SUPPLEMENT TO BLOOMFIELD REFINERY DISCHARGE PLAN APPLICATION, SITE INVESTIGATION AND ABATEMENT PLAN CMS

**RE: Corrective Measures Study (Site Investigation and Abatement Plan)
Giant Refining Company, Bloomfield Refinery
EPA ID# NMD089416416
HWB-GRCB-01-001**

SUBJECT: REQUEST FOR SUPPLEMENTAL INFORMATION (RSI)
CORRECTIVE MEASURES STUDY (SITE INVESTIGATION AND
ABATEMENT PLAN)
GIANT REFINING COMPANY, BLOOMFIELD REFINERY
EPA ID# NMD089416416
HWB-GRCB-01-001

**RE: SITE INVESTIGATION REPORT AND ABATEMENT PLAN
GIANT BLOOMFIELD REFINERY (GW-001)**

Monitoring Well 24 and Hammond Ditch (Lined)

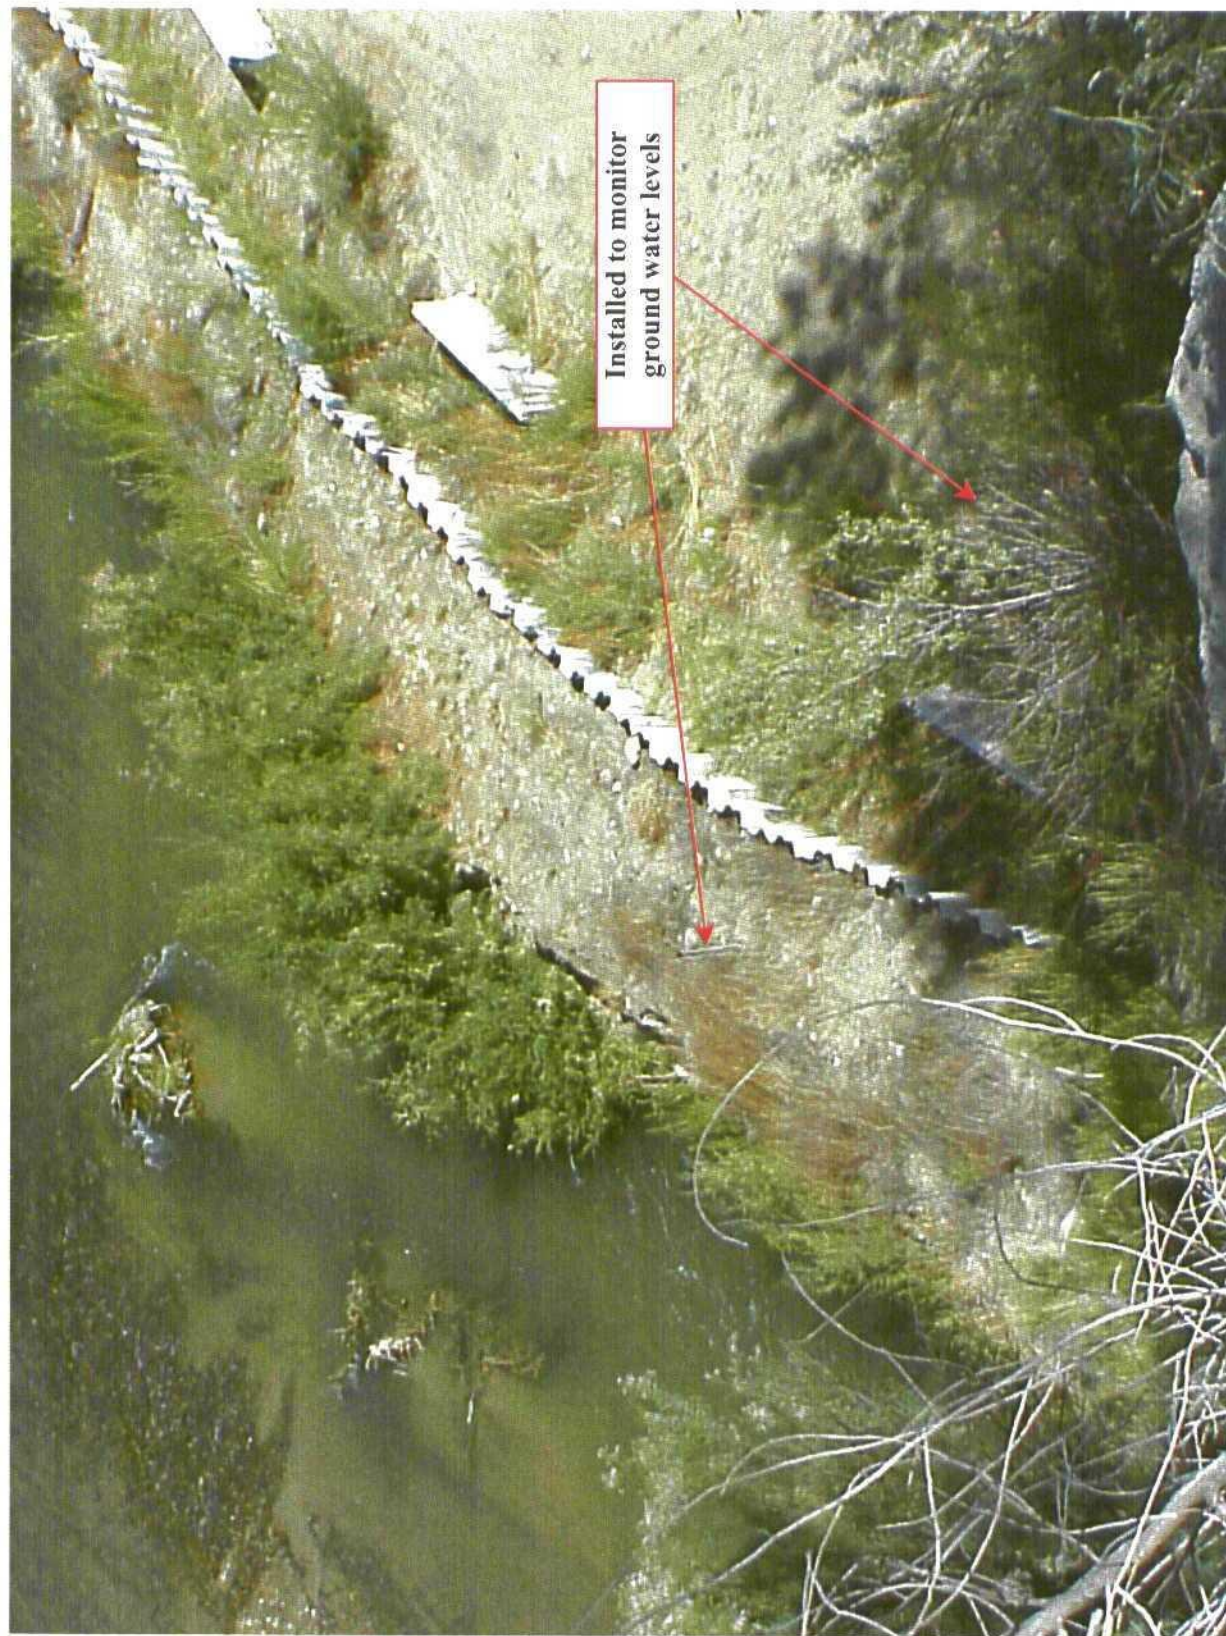
Site plan presenting the location of proposed monitoring wells to be placed downgradient of the Hammond Ditch to monitor the effectiveness of the groundwater recovery and treatment system [the Hammond Ditch French Drain].

Attachment 5 includes 8 ½" by 11" copies of photographs of the monitoring points located at the San Juan River sheet piling and Monitoring Well (MW) 24. One new monitoring well is proposed downgradient of the Hammond Ditch to monitor the effectiveness of the Hammond

Ditch French Drain, and BRC will continue to monitor the downgradient seeps along the bluff, MW-24, and the points at the sheet piling. Water level information on Seep 5 and MW-24 are included in Attachment 3.

One new monitoring well is proposed downgradient of the Hammond Ditch to monitor the effectiveness of the Hammond Ditch French Drain. BRC will also continue to monitor the downgradient seeps along the bluff, MW24, and the points at the sheet piling. Attachment 3 includes water level information on the seeps and monitoring wells downgradient of Hammond Ditch.

Insert Facility Site Map/ Site Plan

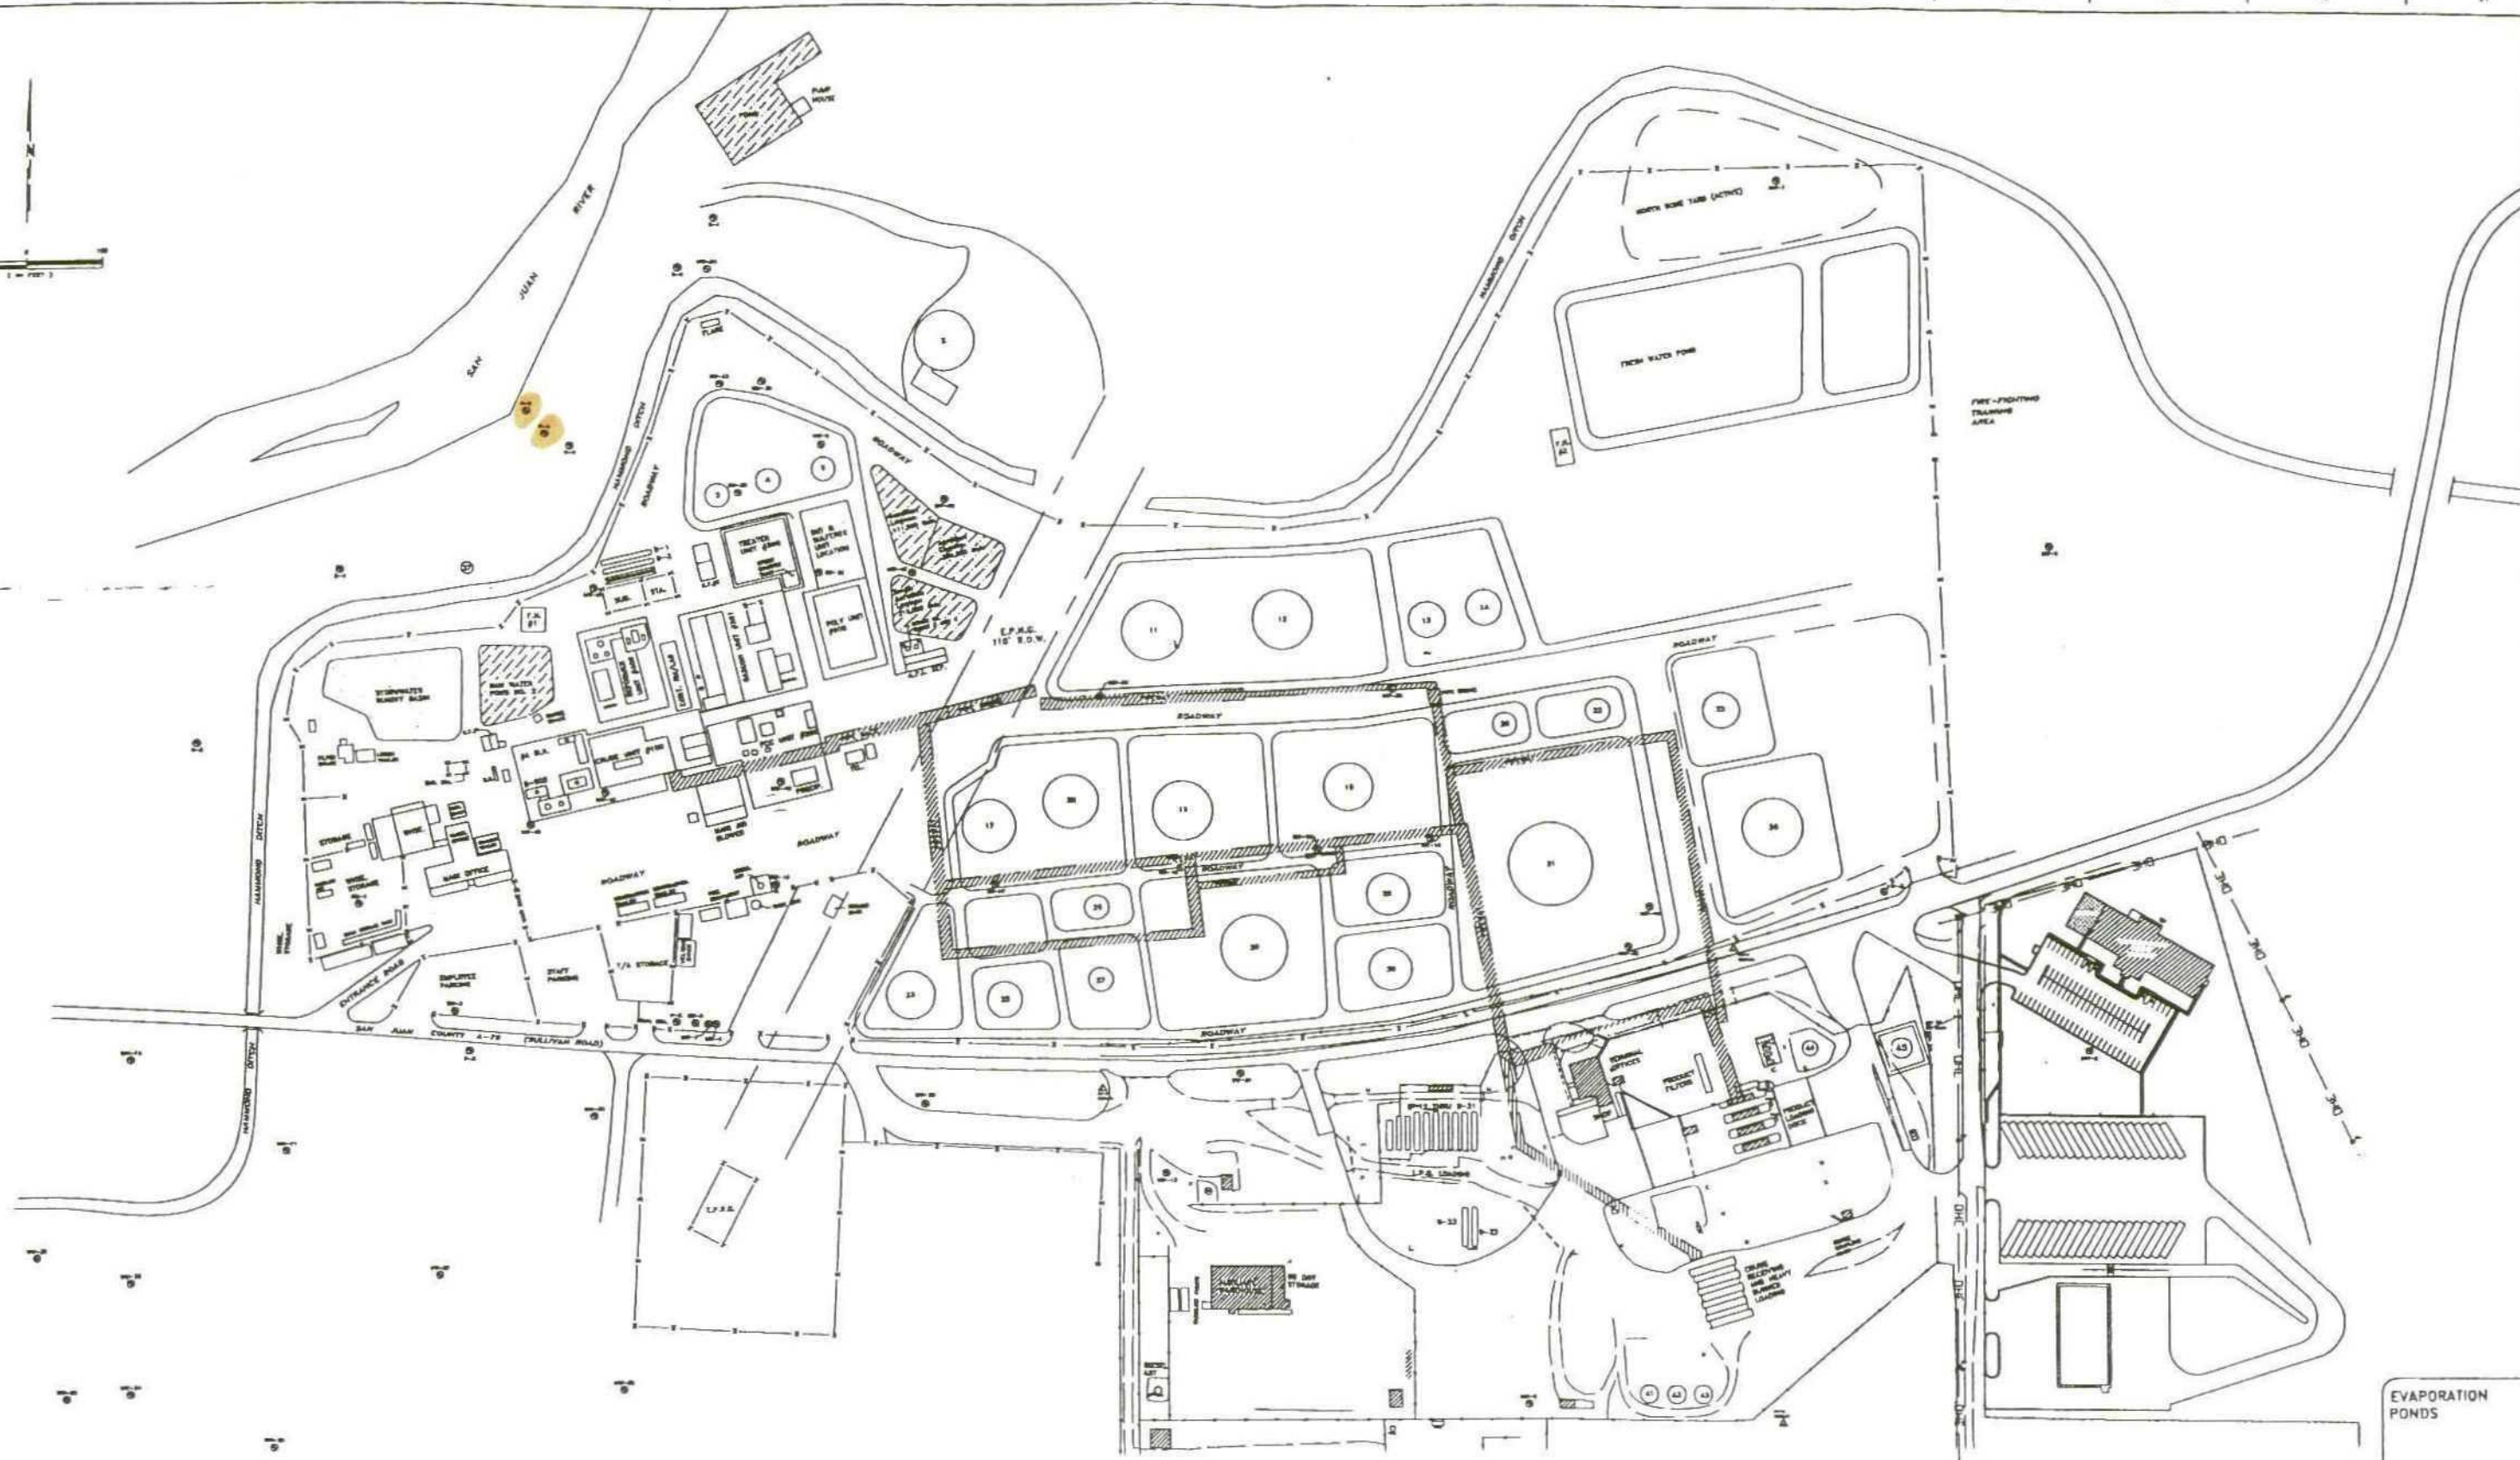
A facility map that includes

- monitoring well locations and refinery features including
- labeled process units;
- above-ground storage tanks; and
- other refinery and terminal features.

Attachment 1 includes a facility site map with monitoring well locations, labeled process units, above-ground storage tanks, and other refinery and terminal features. This map is provided in both 11" by 17" and 24" by 36" (D) sizes. The D size has been included because so much information is being presented that some information may not be legible in the reduced version. In addition, an 8 1/2" by 11" copy of an October 9, 1997 satellite image of the facility has been included for reference. This image may also be found at: <http://terraservert.homeadvisor.msn.com/image.asp?S=10&T=1&X=1171&Y=20327&Z=13&=2>.

Attachment 1 includes a facility site map/site plan with monitoring well locations, labeled process units, above-ground storage tanks, and other refinery and terminal features. This map is provided in both 11" by 17" and 24" by 36" (D) sizes. The D size has been included because with the amount of information that is being presented some information may not be legible in the reduced version. In addition, an 8 ½" by 11" copy of an October 9, 1997 USGS aerial photograph of the facility has been included for reference. This image may also be found on the internet at:

FIGURE 2

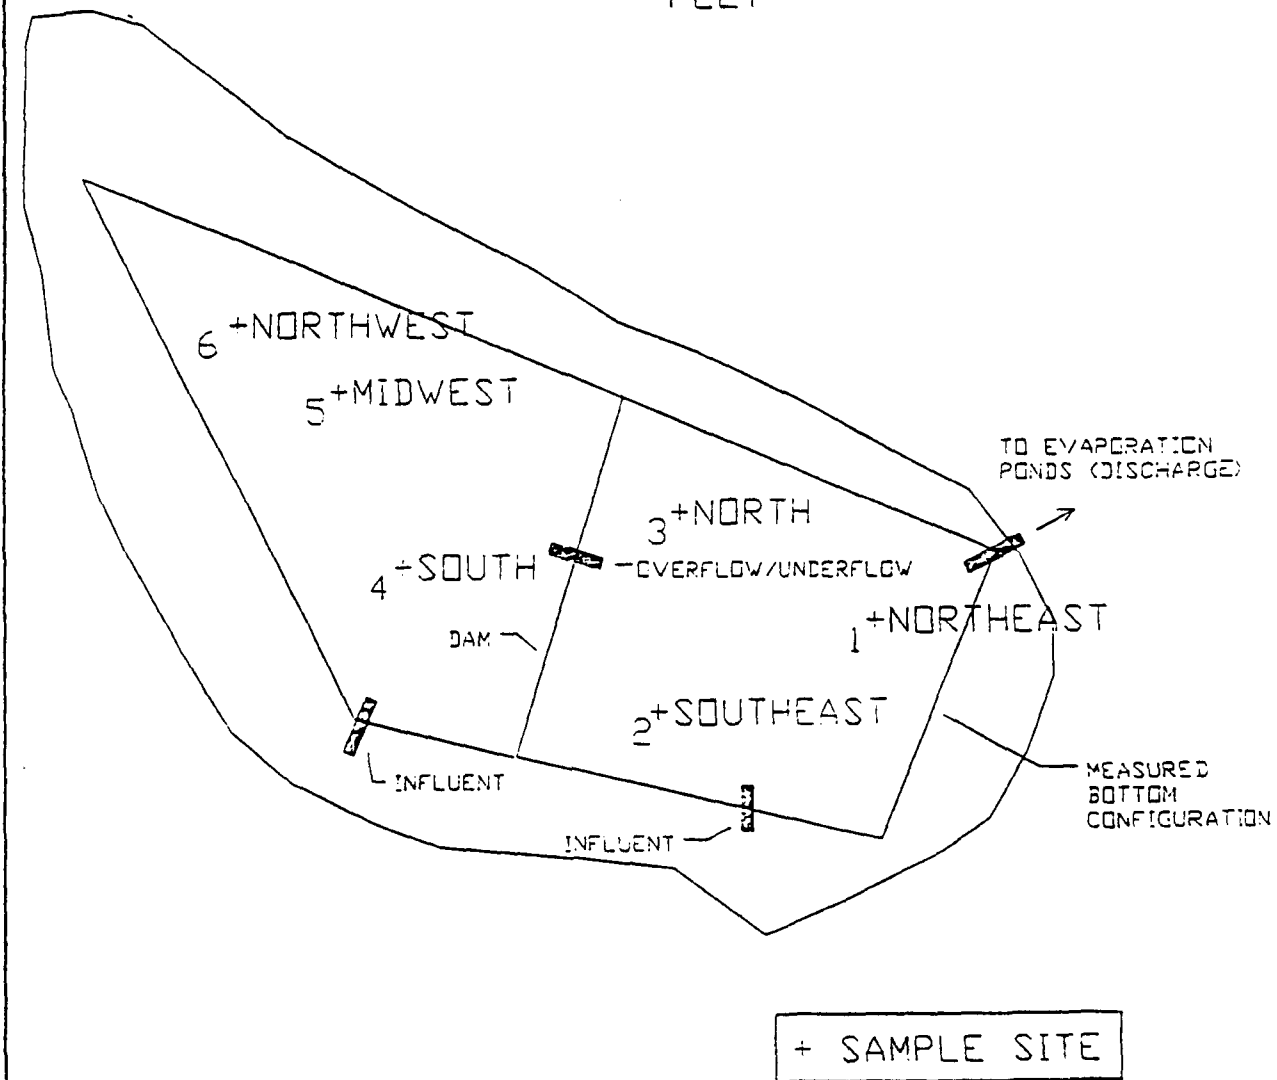
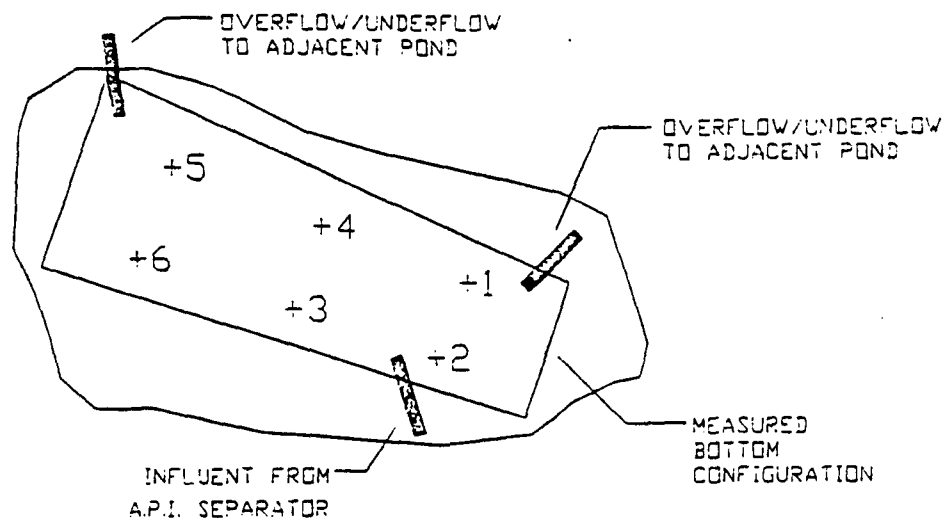
Soil samples obtained from beneath the aeration lagoon liners in 1985 ... Provide a site plan presenting facility features and boring locations.add boring SHB-2 to Plate 10.

- 3.1.3 Soil samples obtained from beneath the aeration lagoon liners in 1985 were likely composite samples therefore a lack of significant volatile organic compound (VOC) detections is not unexpected. TPH and VOCs were detected during drilling investigations conducted within the process areas; however, no site plan is provided showing the boring locations relative to facility features including the aeration lagoons. Provide a site plan presenting facility features and boring locations. In addition, Boring SHB-2 is not shown on Plate 10 (boring locations). Please add Boring SHB-2 to Plate 10.

Attachment 3.1.3 includes the report and locations of the borings below the North and South API ponds (referred to as the "aeration lagoon" above). In addition, this information has been transferred to the site plan provided in Attachment 1, which includes the ponds and the boring locations in the ponds.

San Juan River Sheet Piling and Slurry Wall with Monitoring Points

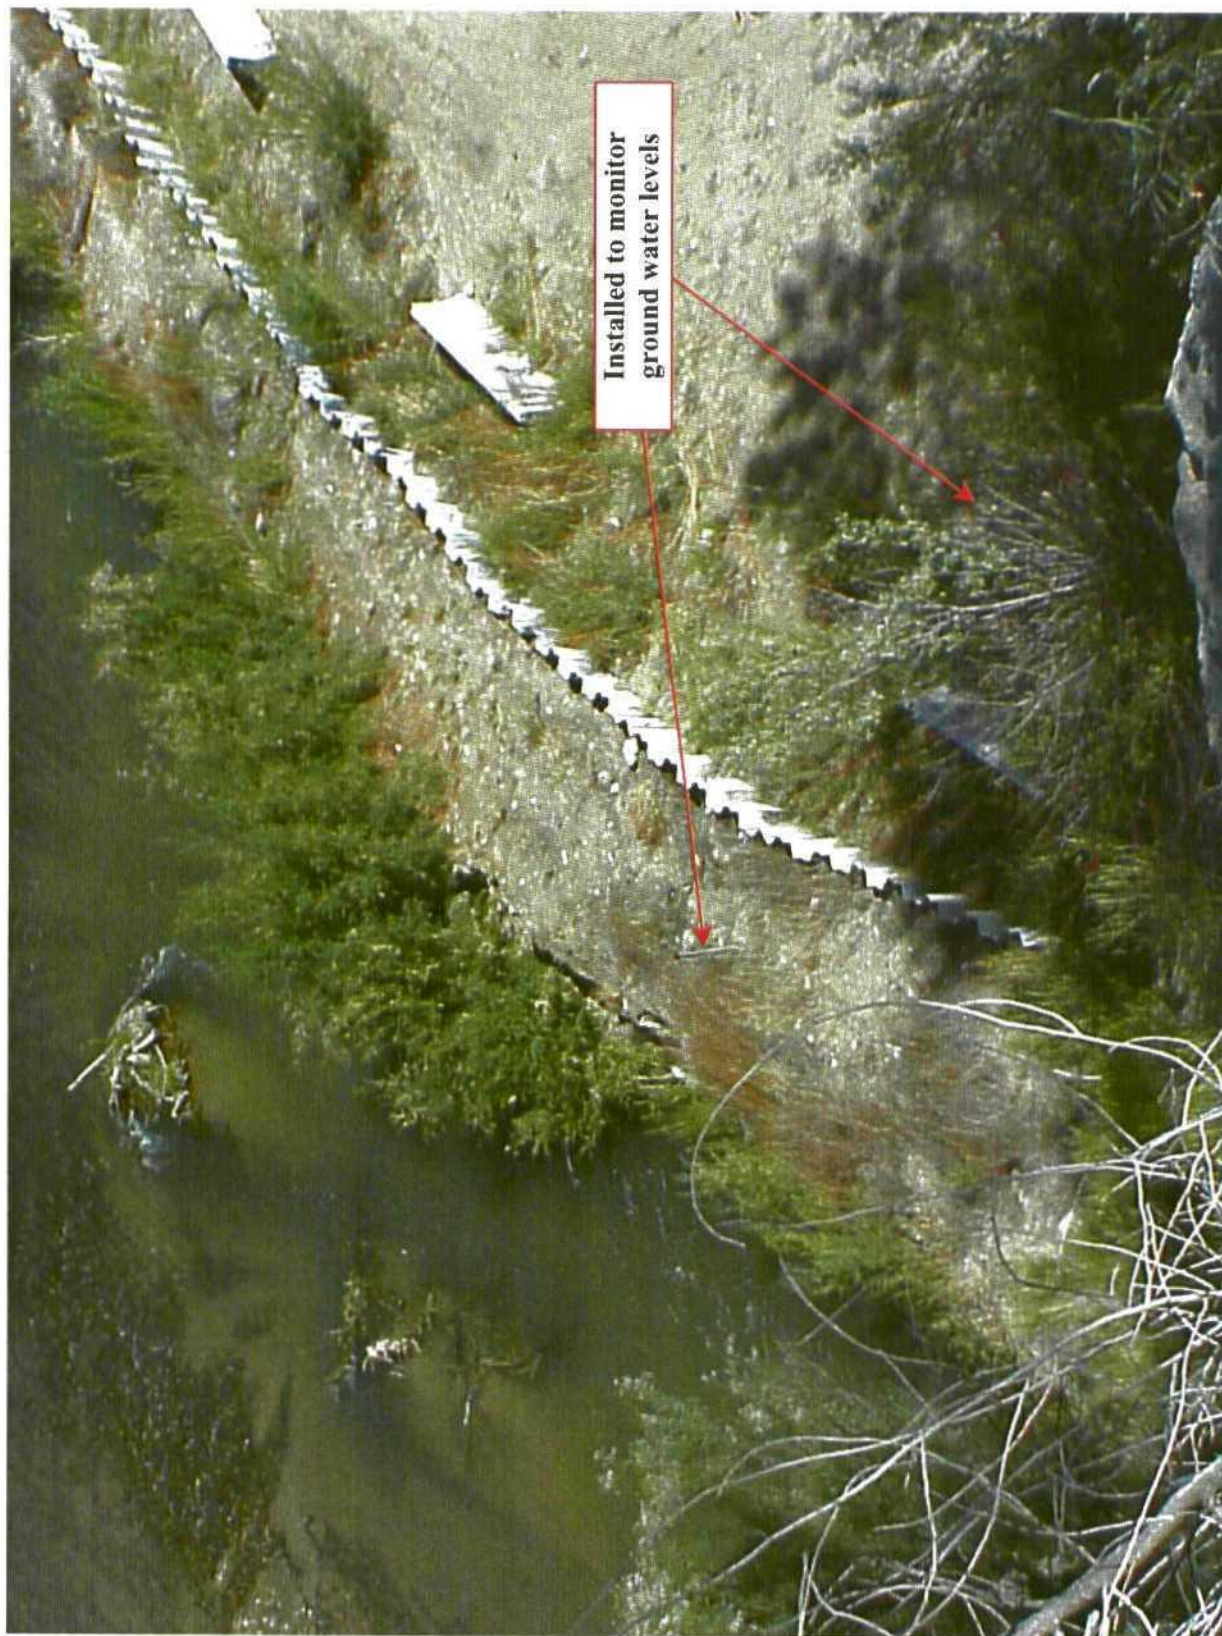
A site plan that includes the location(s) or proposed locations of monitoring wells in the vicinity of the barrier at the San Juan River to monitor BETX, TPH as GRO and DRO, and OCD general chemistry parameters (major cations and anions).

Attachment 7 includes an 8 ½" by 11" copy of a photograph of the monitoring points at the San Juan River sheet piling and an 11" by 17" site plan with these points highlighted. These monitoring points are also included in the site plan provided in Attachment 1. The groundwater monitoring and sampling plan included in Attachment 6 identifies a plan for the requested sampling at these points.
